BRIDGEWOOD SUBDIVISION
 SAN ANTONIO, BEXAR COUNTY
 PRELIMINARY OVERALL AREA DEVELOPMENT PLAN

CITY OF SAN ANTONIO POADP APPLICATION

Re: Bridgewood (Amending)

POADP # 628-A

P.O.A.D.P. NO. **628-A**

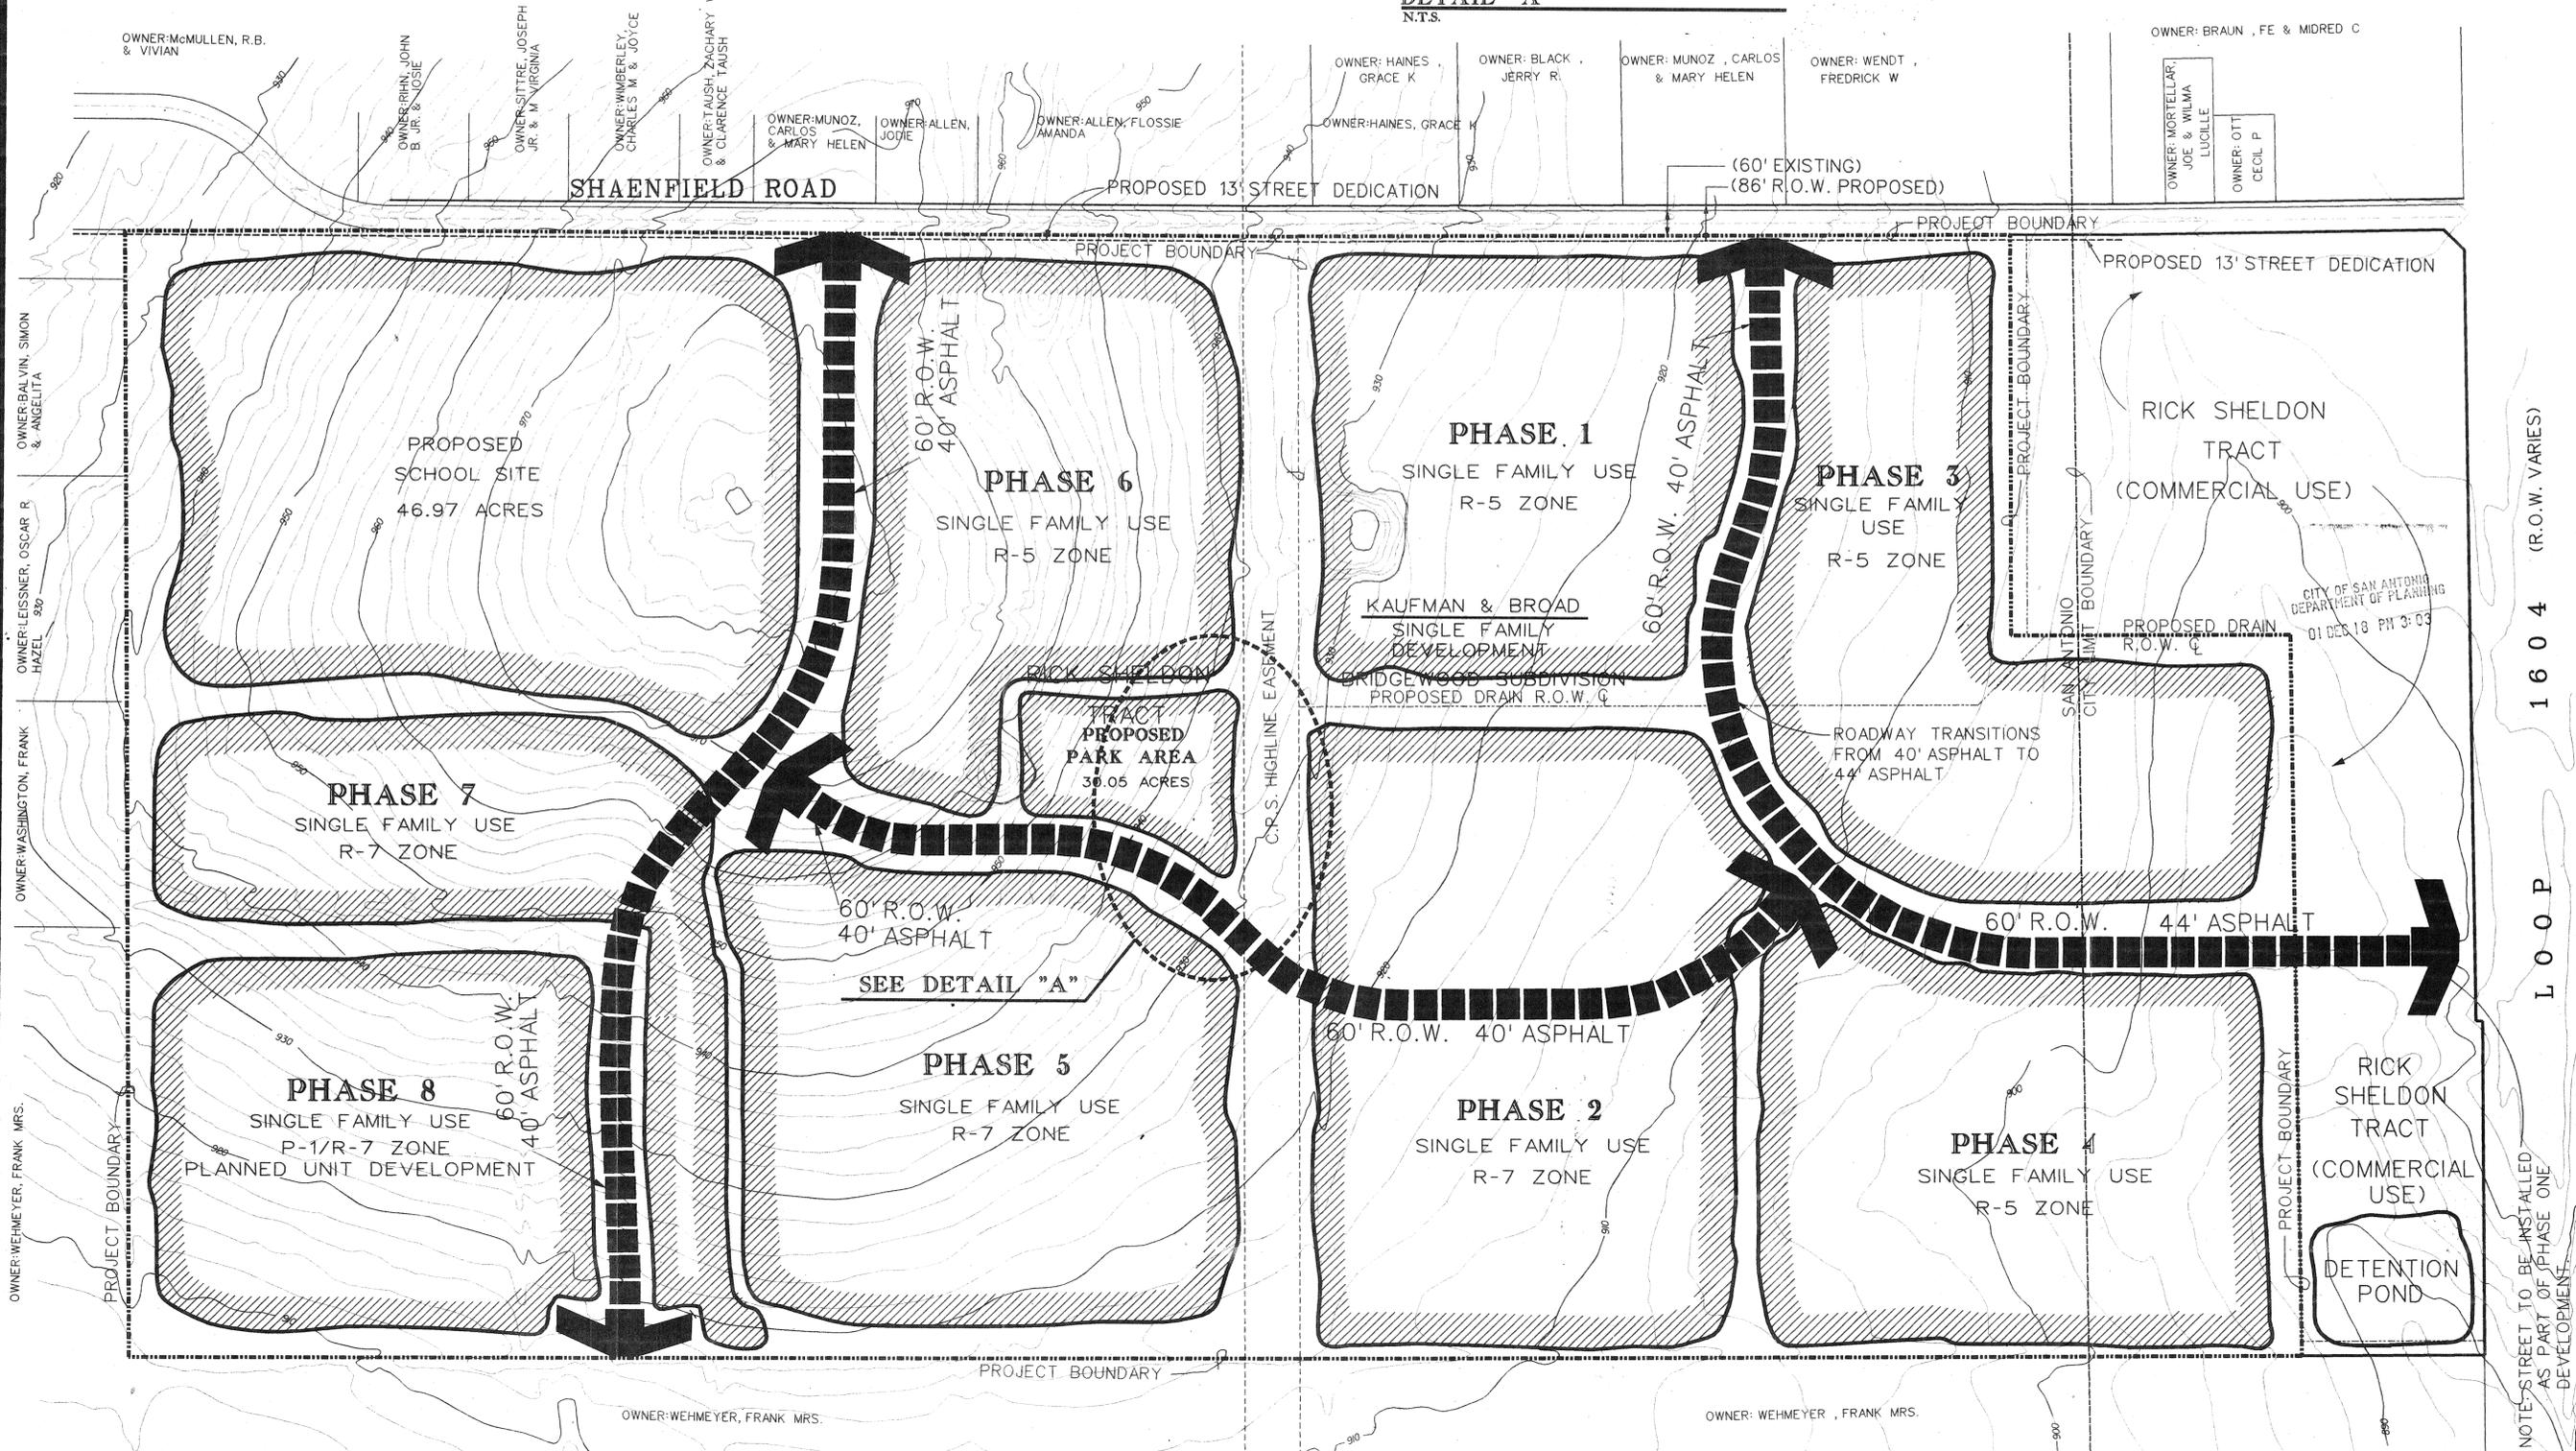
- In consideration of public safety and convenience, excessive grades by reason of topography should be avoided in street layouts and arrangements.
- Any access and R.O.W. issues along state facilities will need to be resolved with the Texas Department of Transportation (TXDOT). For information about these requirements you can contact TXDOT at 615-5814.
- This development will need to comply with tree preservation ordinance #85262. For information about these requirements you can contact Building Inspections at 207-7102.
- It will be expected that you will plat all of the property depicted in your Master Development Plan (M.D.P.) (formerly POADP), to include floodplains, drainage areas and open space.
- I would encourage you to work closely with the school district, so that they can plan accordingly.

- Based on the topography, a Flood Plain Study and drainage review will probably be required during the platting process.
- A Level-3 TIA will be required to be submitted to the Department of Public Works prior to approval of the plat for phase two.
- This development will need to comply with tree preservation ordinance #85262. For information about these requirements you can contact Building Inspections at 207-7102.
- It will be expected that you will plat all of the property depicted in your POADP, to include: floodpains, drainage areas and open space.
- I would encourage you to work closely with the school district, so that they can plan accordingly.
